ARCHITECT'S ADDENDUM

ADDENDUM NUMBER: 3

RE: Will County Recorder and Coroner

Project No.: 13357

Sheet A4.0

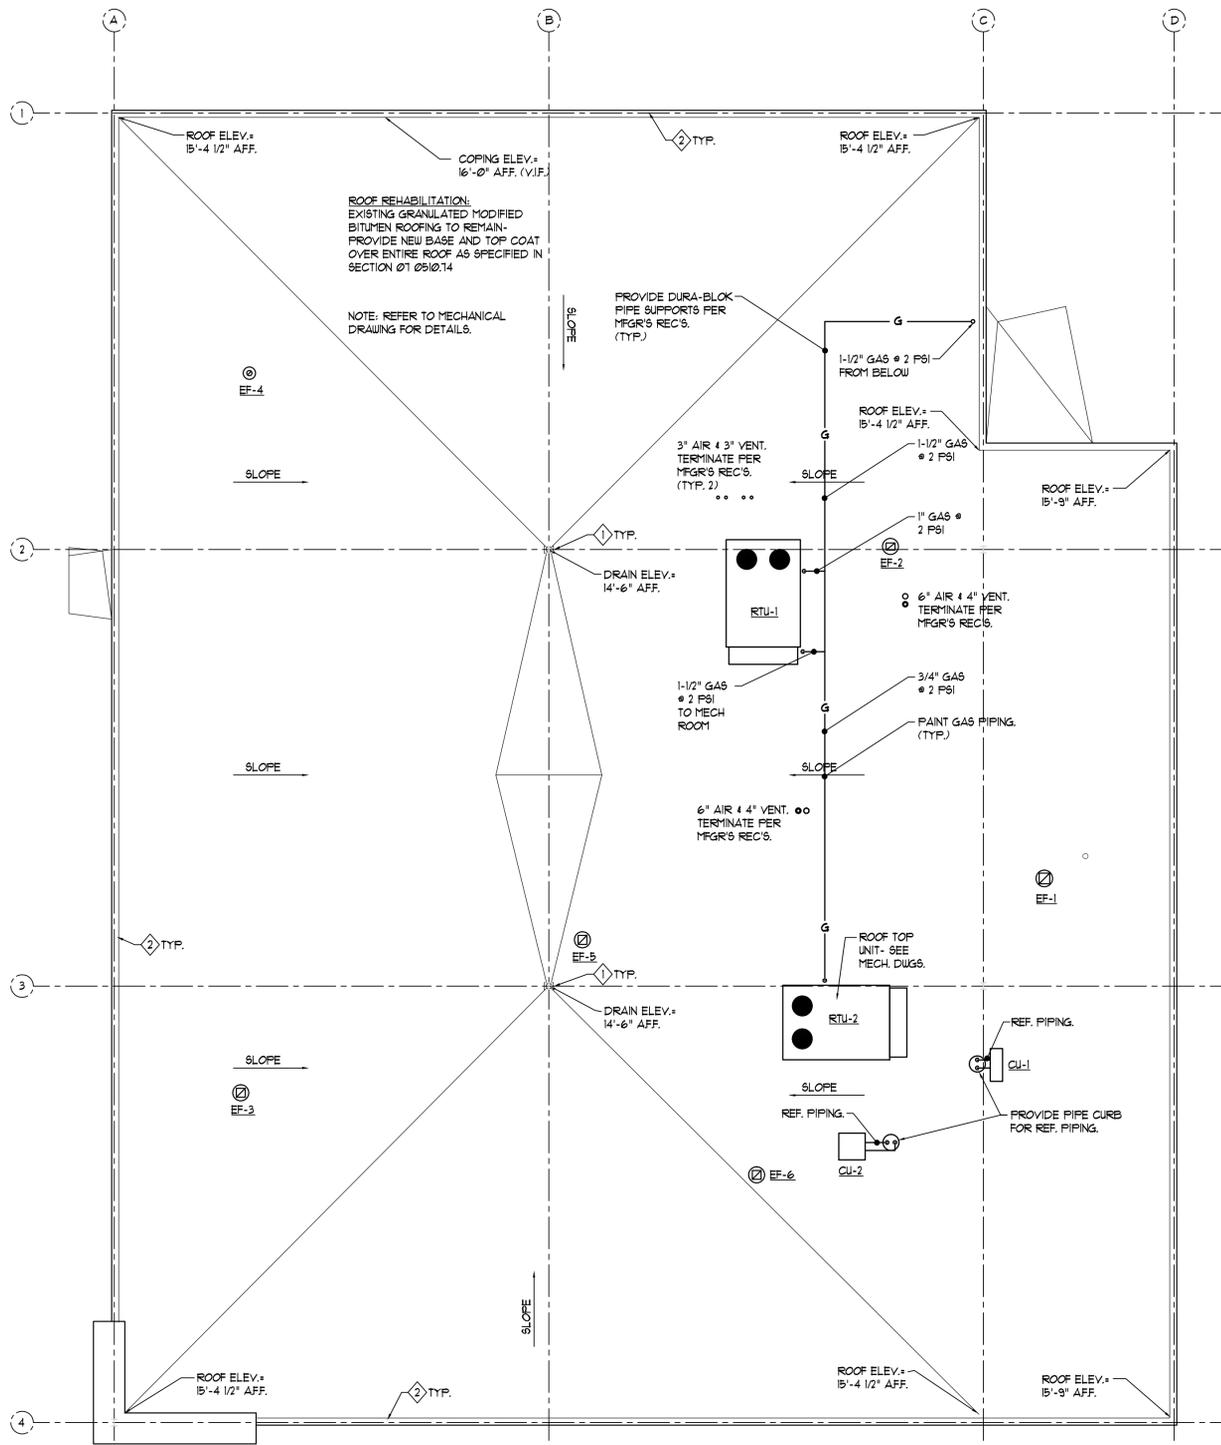
1. At roof drains remove sumps to deck and install new tapered insulation, new lead flashing and new 2 ply smooth modified bitumen membrane. Add a new cast iron drain strainer. Install any missing drain hardware; replace existing drain hardware as necessary.
2. Replace all perimeter sheet metal and base flashing with new smooth modified bitumen membrane and new 24 ga. kynar coated sheet metal held with a continuous 22 ga. cleat.
3. Remove all curbs of obsolete equipment and patch all roof penetrations.

ROOF PLAN AND DETAILS

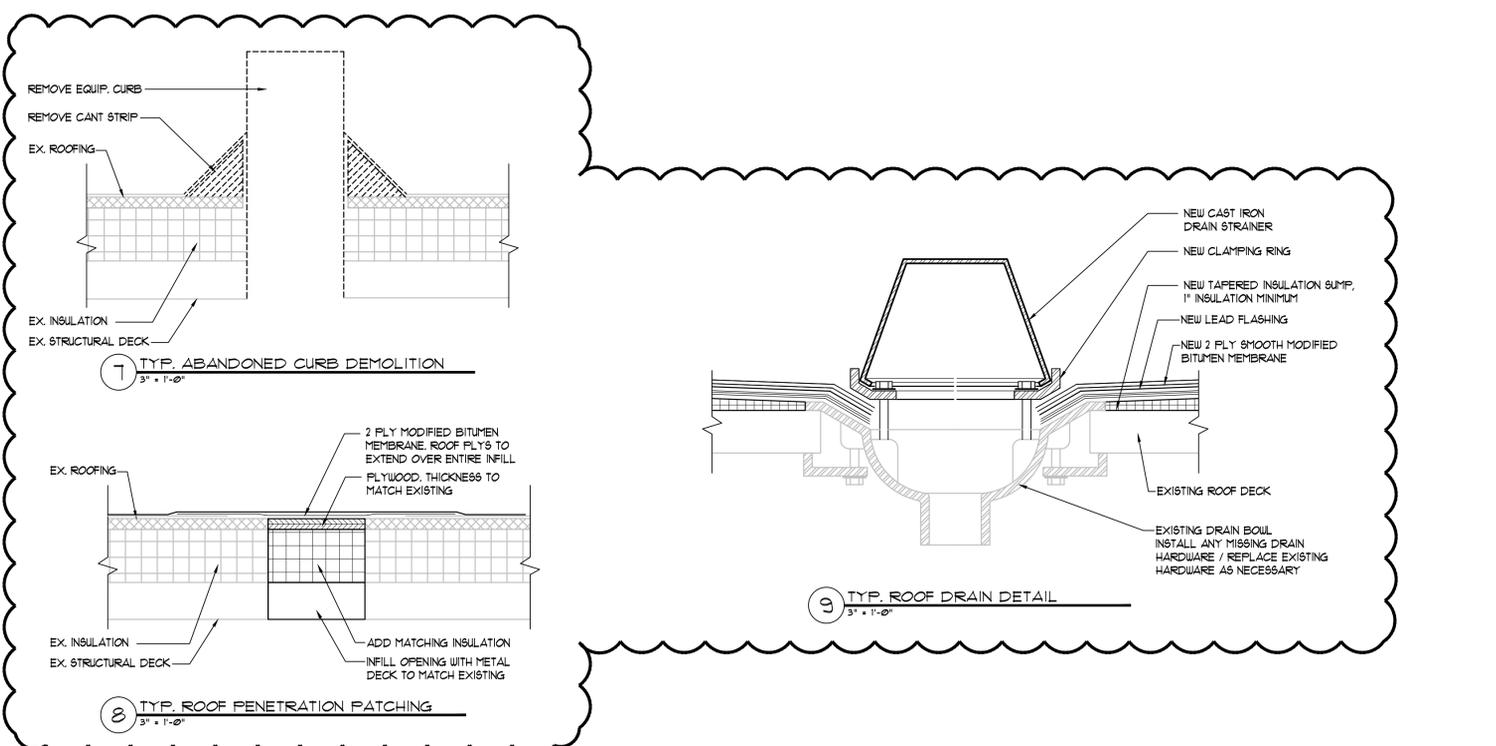
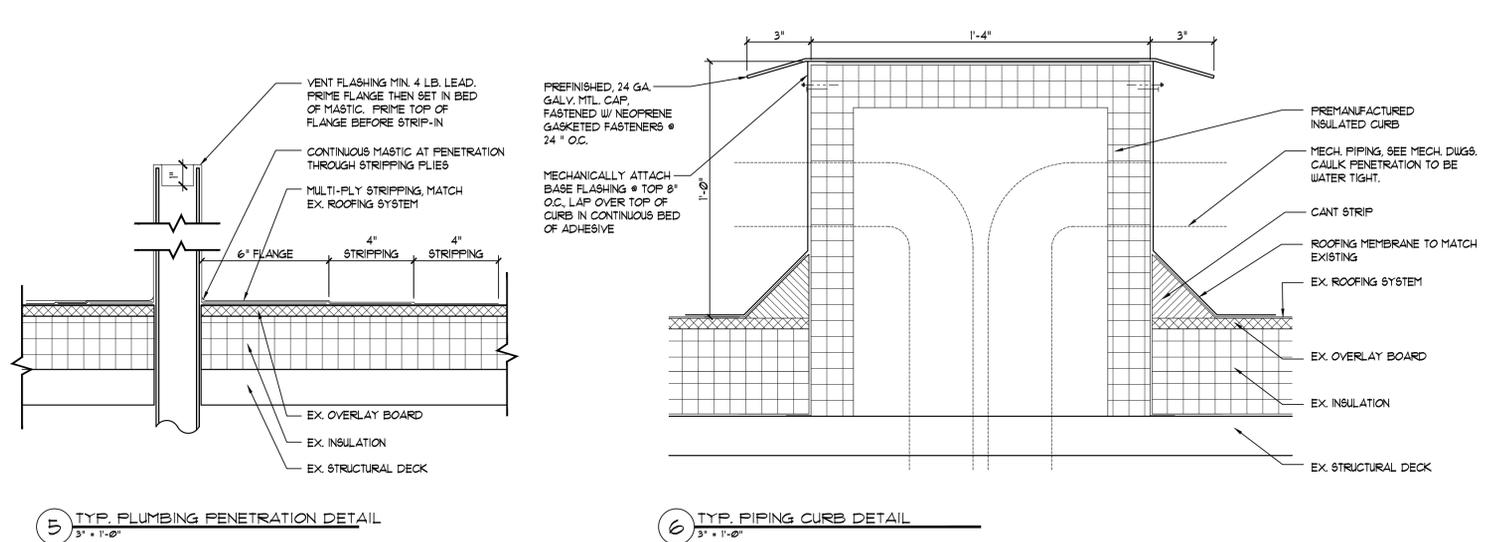
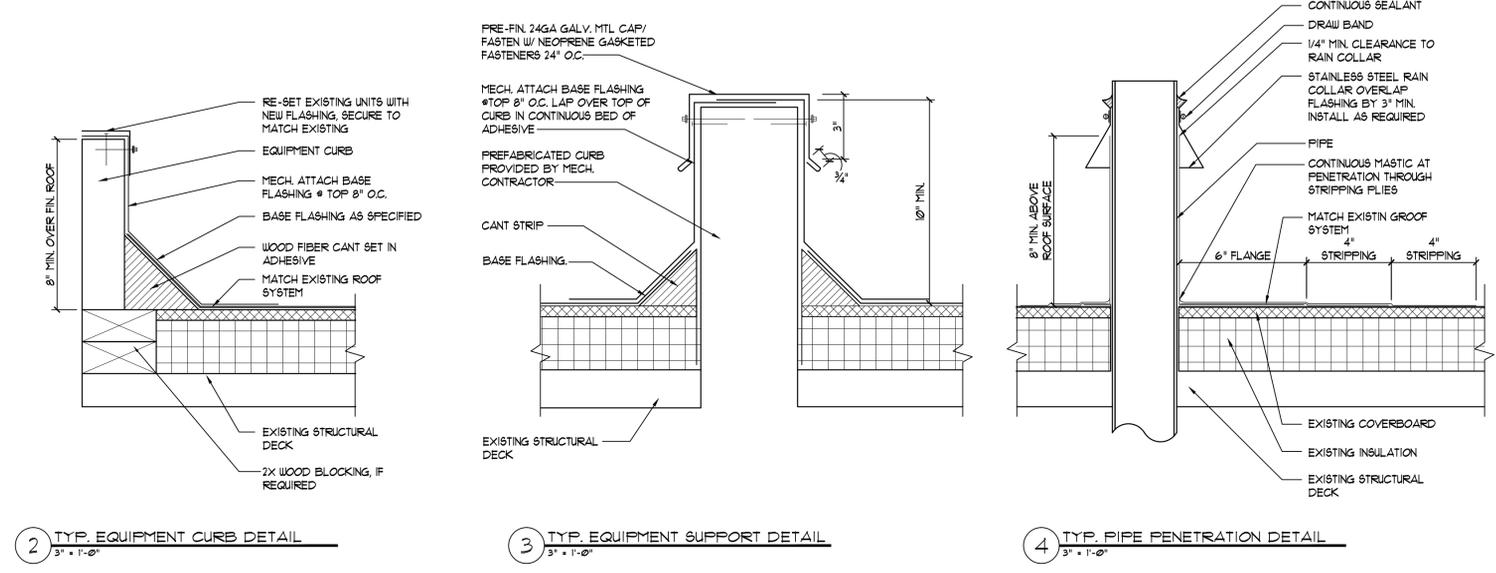
1 AT ROOF DRAINS REMOVE SUMPS TO DECK AND INSTALL NEW TAPERED INSULATION, NEW LEAD FLASHING AND NEW 2 PLY SMOOTH MODIFIED BITUMEN MEMBRANE. ADD A NEW CAST IRON DRAIN STRAINER. INSTALL ANY MISSING DRAIN HARDWARE / REPLACE EXISTING DRAIN HARDWARE AS NECESSARY. REFER TO DETAIL 9/4/0.

2 REPLACE ALL PERIMETER SHEET METAL AND BASE FLASHING WITH NEW SMOOTH MODIFIED BITUMEN MEMBRANE AND NEW 24 GA. KYNAR COATED SHEET METAL HELD WITH A CONTINUOUS 22 GA. CLEAT.
